Consultants Advice

HABITAT PALMER ST DEVELOPMENT

Project No: 20-1169 **CA NO:** 01
Date: 31/08/2020 **Action:**
From: Samuel Simpson **Information:**

Item	Description
1	Foundation Recommendations – Site Wide

MASTERPLAN OPTION 3

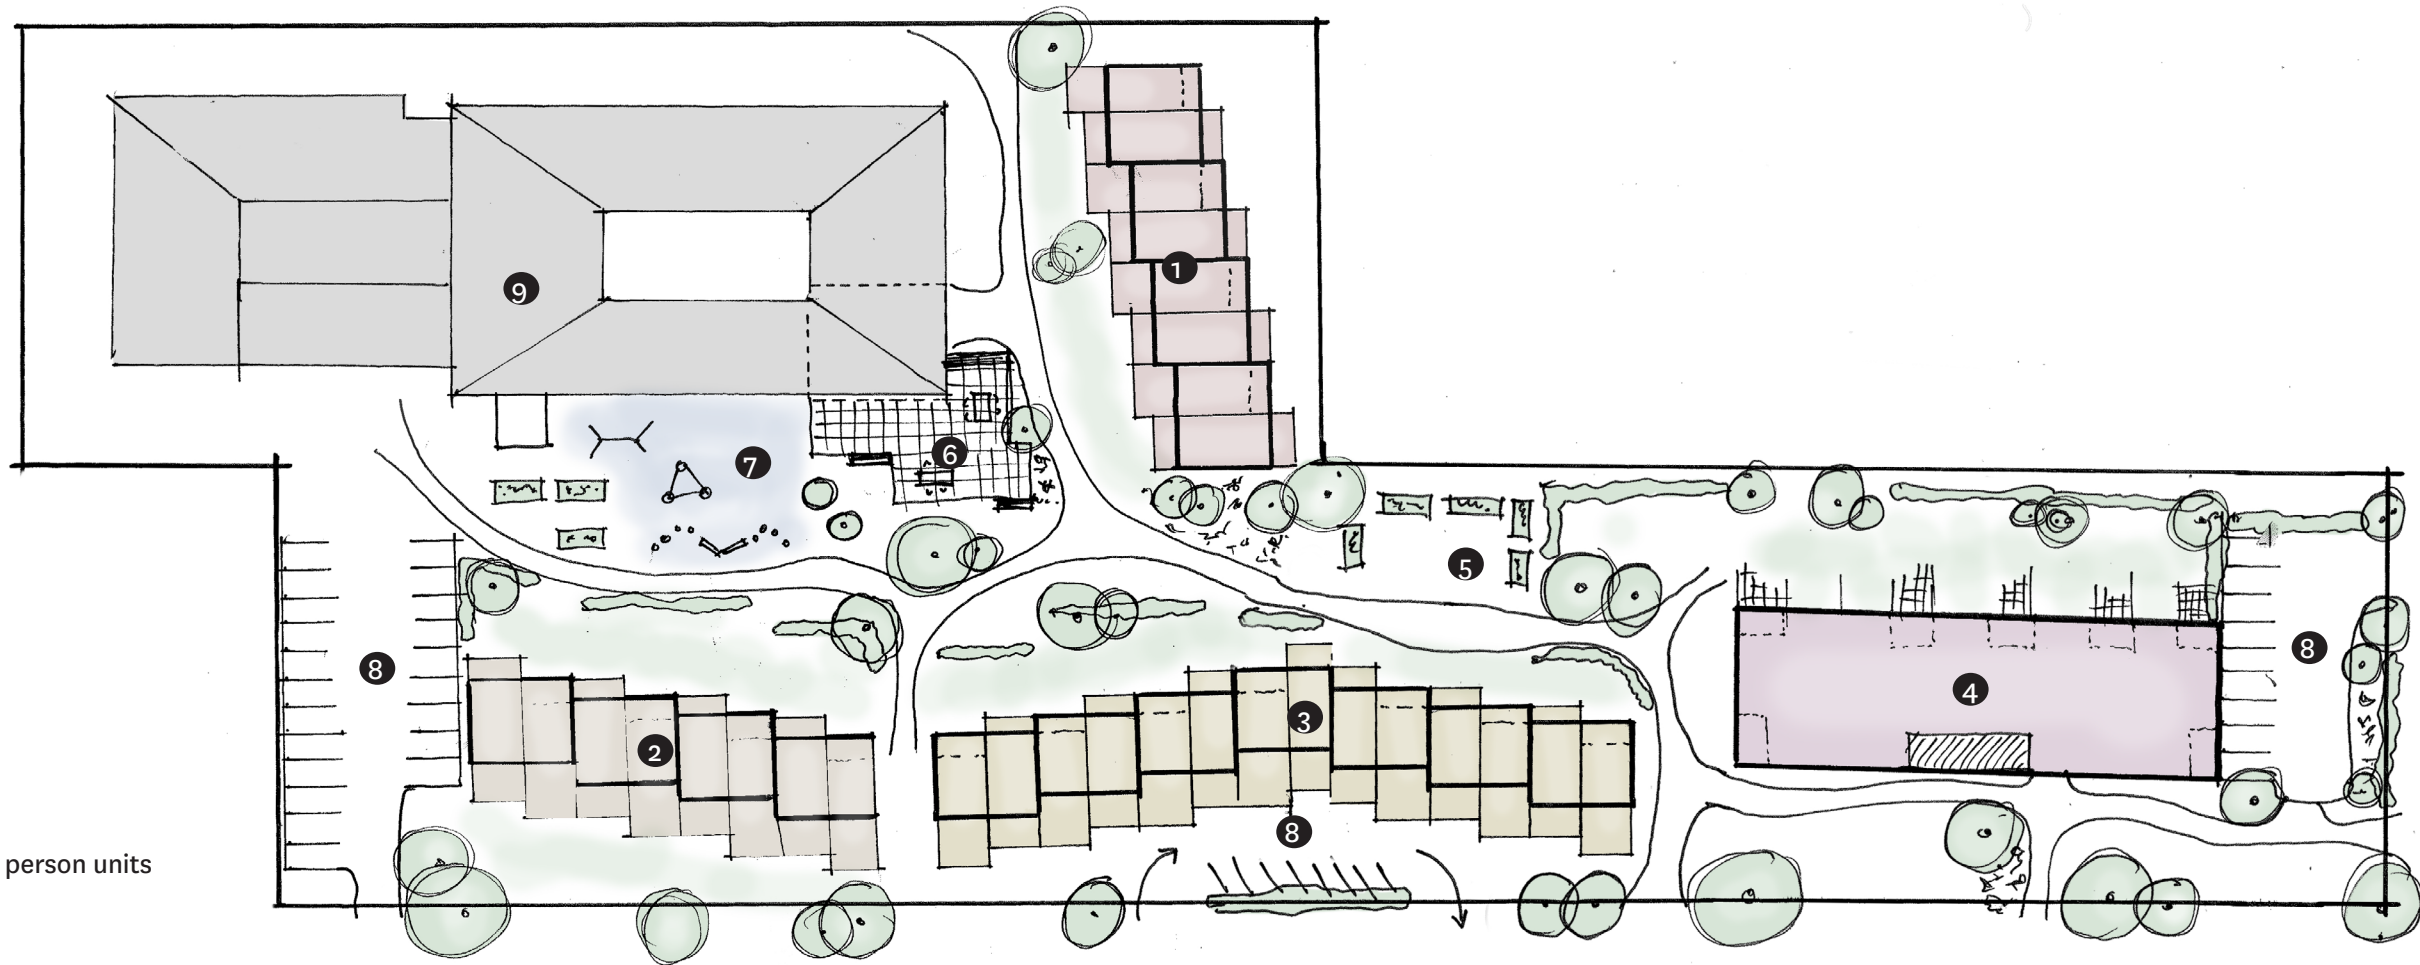
Stage 1 is shown as 1 and 2 storey building. It is located in the area of the site that is thought to have the deepest fill (refer AECOM interpreted fill depth contours). Accordingly, excavate and replace is unlikely to be viable. Foundations for Stage 1 will therefore need to be piled. Suitability of this area for piling should be further investigated for potential large obstructions.

3. Re-evaluate architectural scheme and staging.
4. Detailed Geotechnical Assessment for Stage 1, and also a preliminary assessment of Stages 2, 3 and 4 to assess likely future site constraints.

7. Confirm site layout and mid floor construction of multi-level units.

Testing locations and fill depth

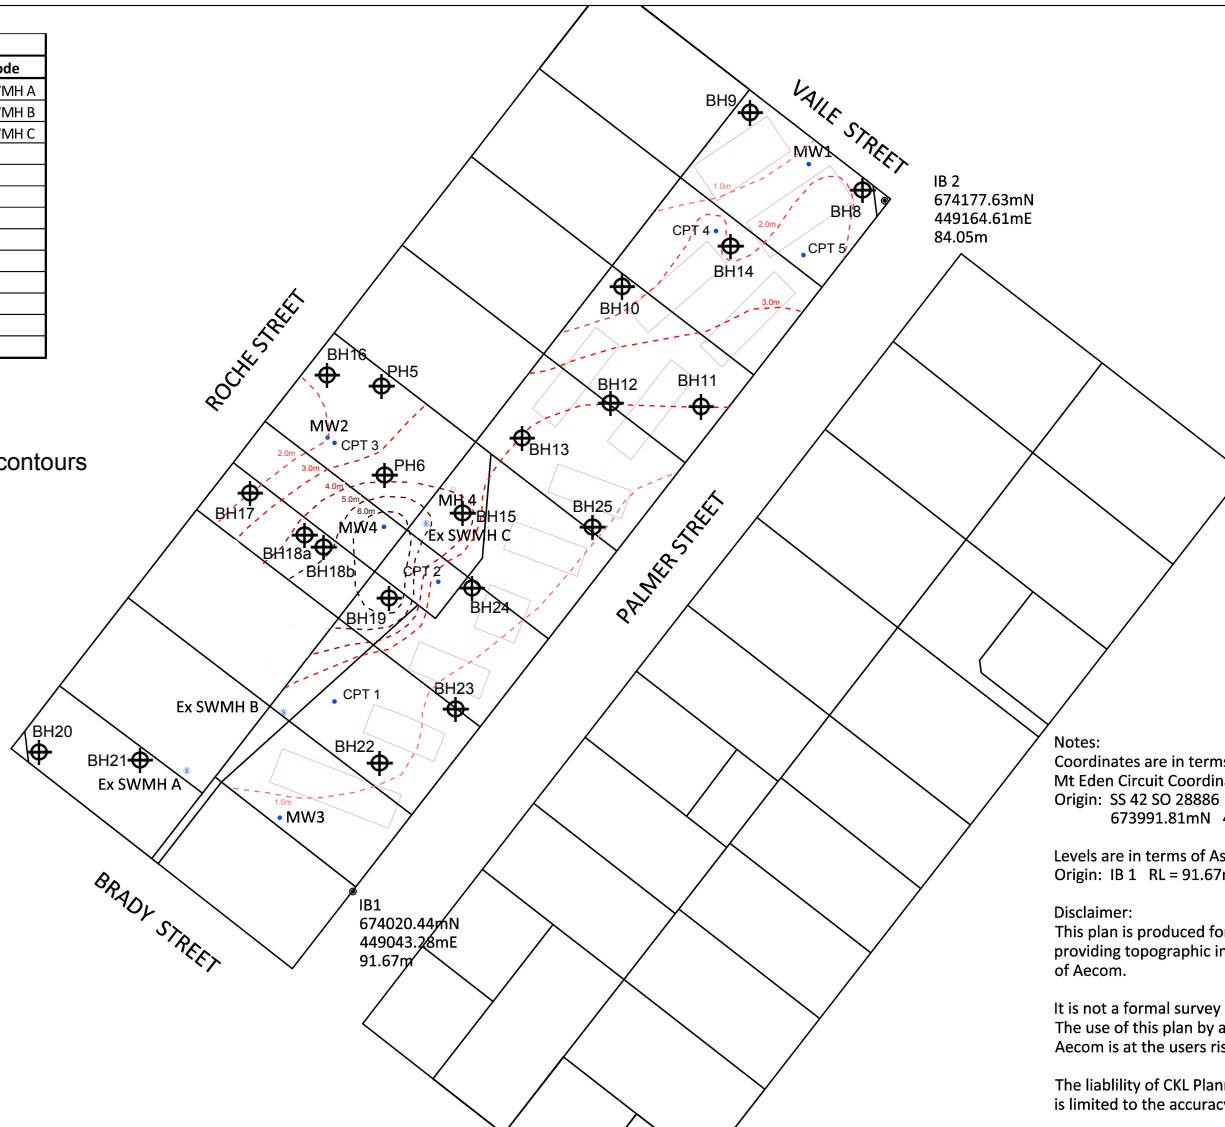
Given the site was an existing landfill site, any proposed earthworks will be affected. For this reason, BCD would recommend an environmental consultant is engaged. As can be seen in the previous AECOM reports, the landfill ranges from approx. 1m in depth to 6m in depth in places, so the earthworks and foundation solutions will vary significantly, and solutions may vary across the site to balance cost and engineering implications. It is also likely that in places the landfill may need to be capped or have suitable GAS Membranes in place which may also affect the foundation options in terms of constructability and cost. The level of engagement may depend on what the final foundation solution may be and require a review of the associated risk.

Where the extent of the landfill is relatively shallow, it may be more cost effective to excavate the old fill and replace with an engineered fill, however this would need to be reviewed in conjunction with the environmental consultant. BCD would recommend that the landfill contours be overlain onto the site master plan as if possible, and it may be cost effective to alter some of the building layouts to suit the shallower fill depths encountered.

Sheet Title
Existing Services

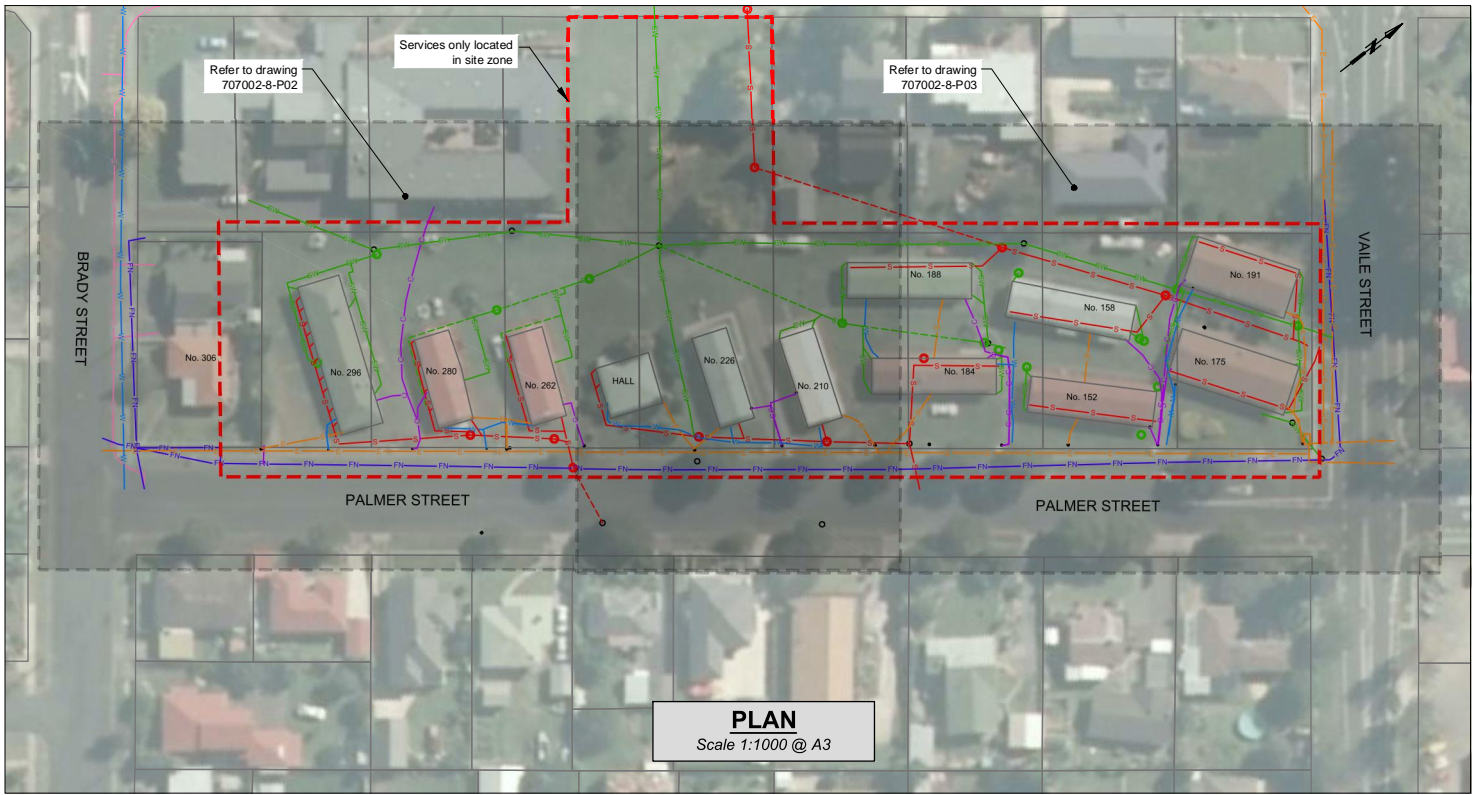
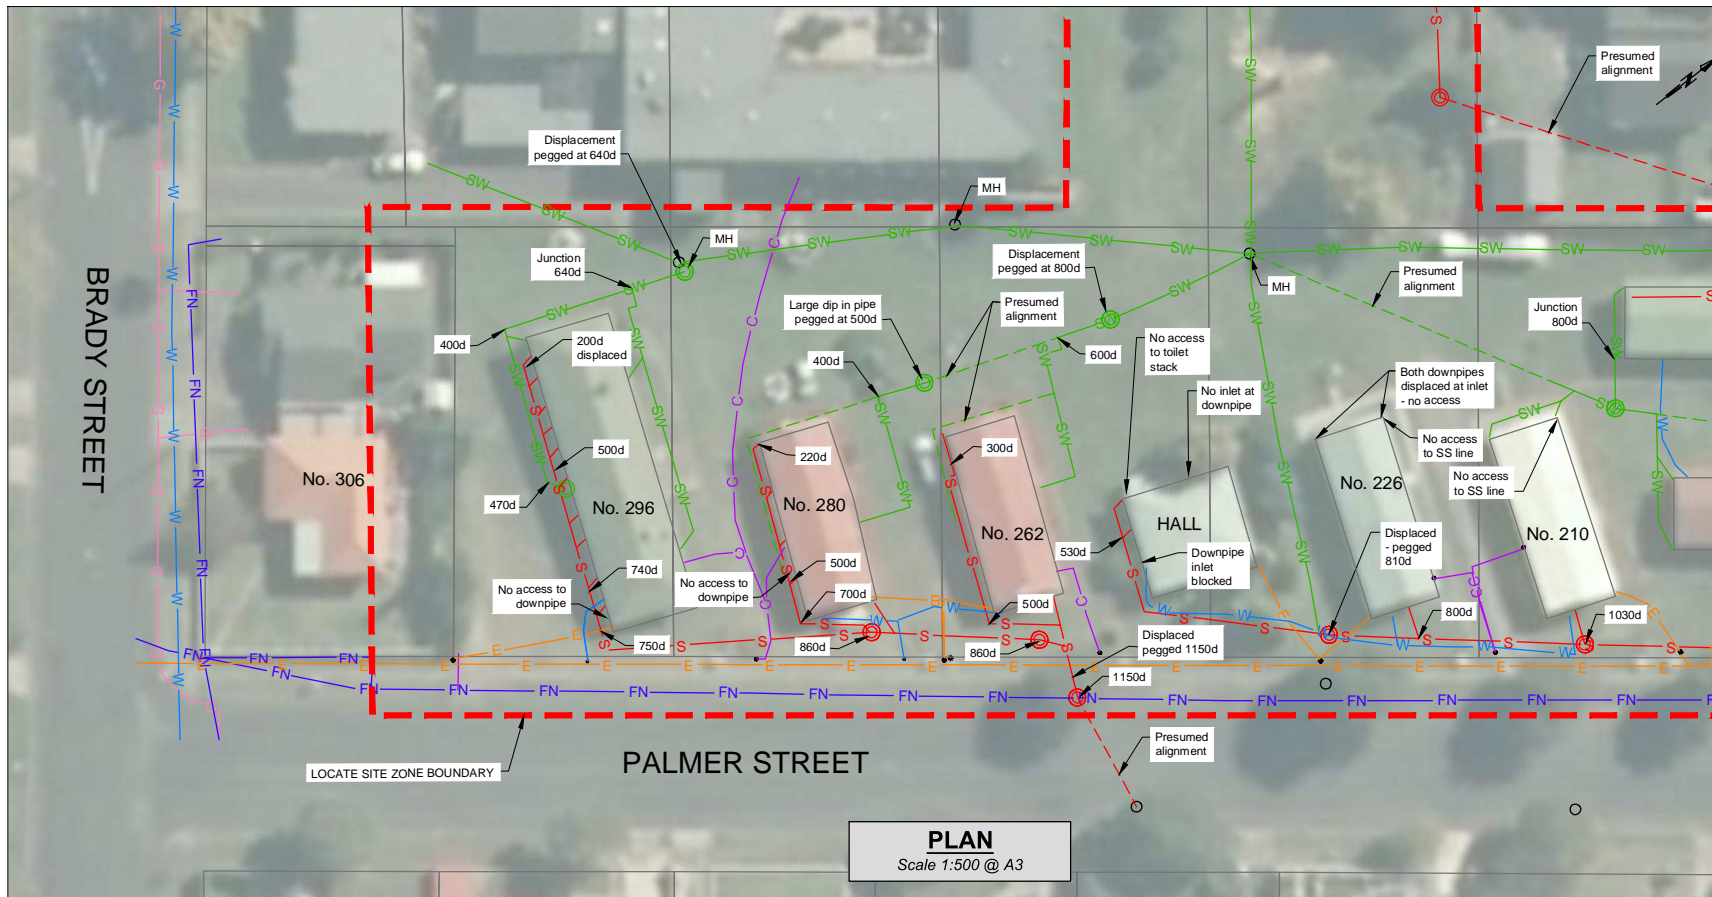
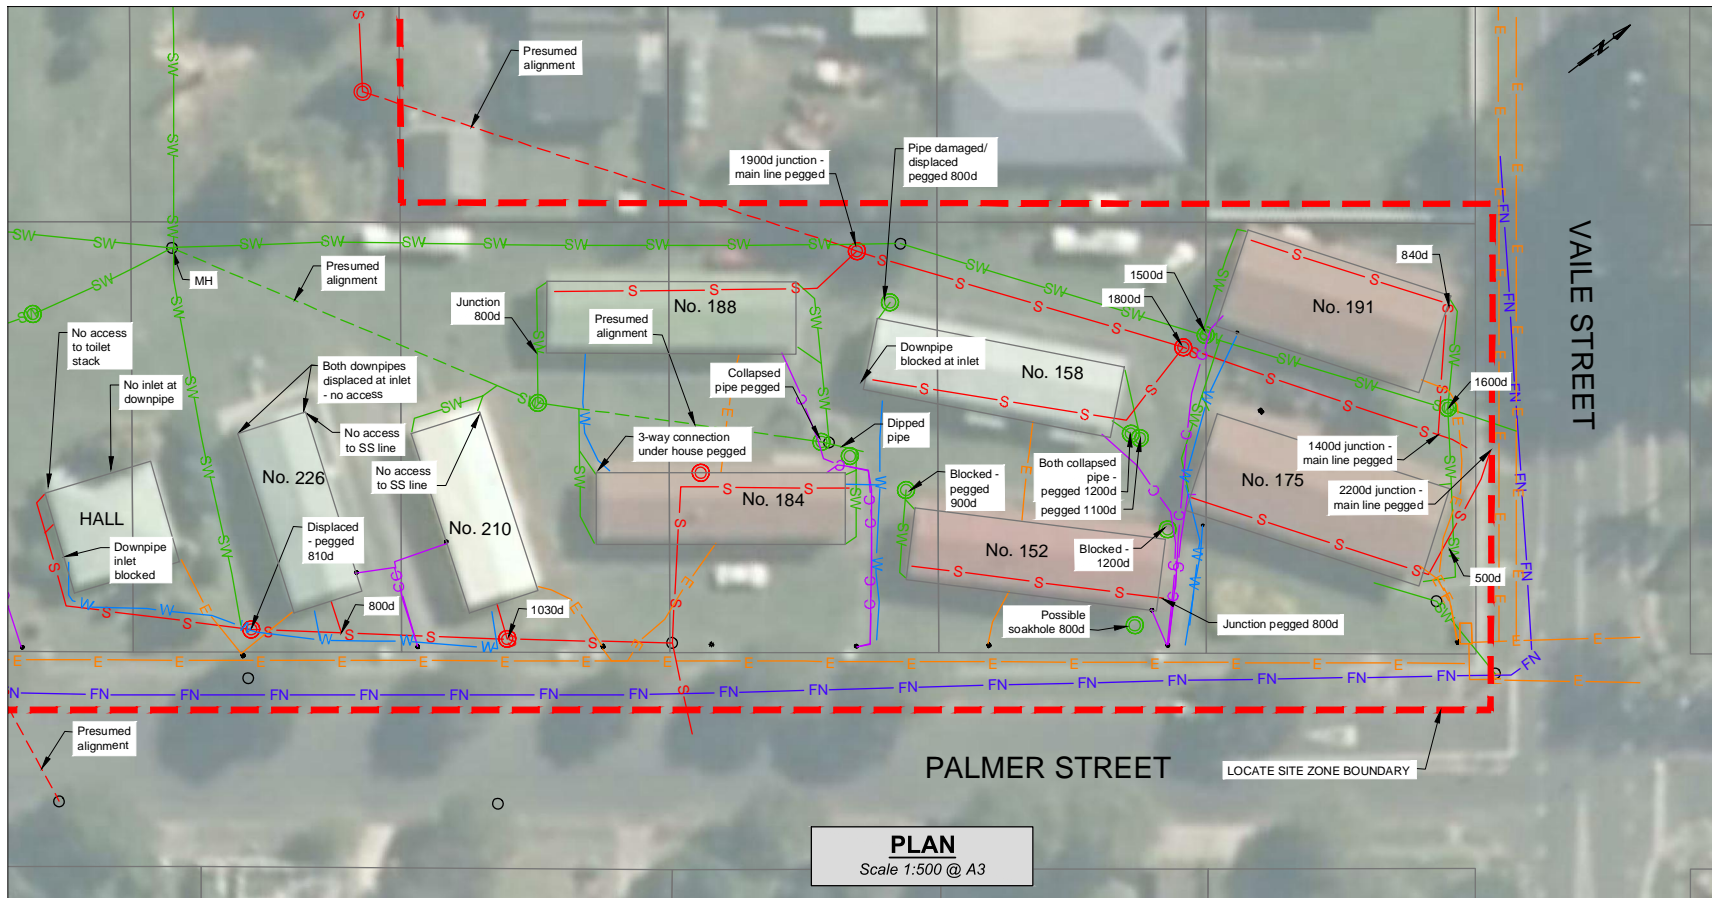
As outlined within the Waipa GIS and associated AECOM reports, there are a number of existing services on site. The condition is generally noted as average to poor with sagging and joint displacements noted. At this stage it is unclear what extent of services will be removed and capped off, or have existing routes altered to suit the new site layout. However, it is expected that some of the foundations may require bridging of the existing services, and therefore will require the foundation systems to be suitably robust. Once the overall site master plan has been confirmed, BCD would recommend a full site survey be completed alongside a services

assessment so a suitable scope can be provided to understand the extend of services that need to be re-routed, abandoned and removed, or bridged by proposed new structure.
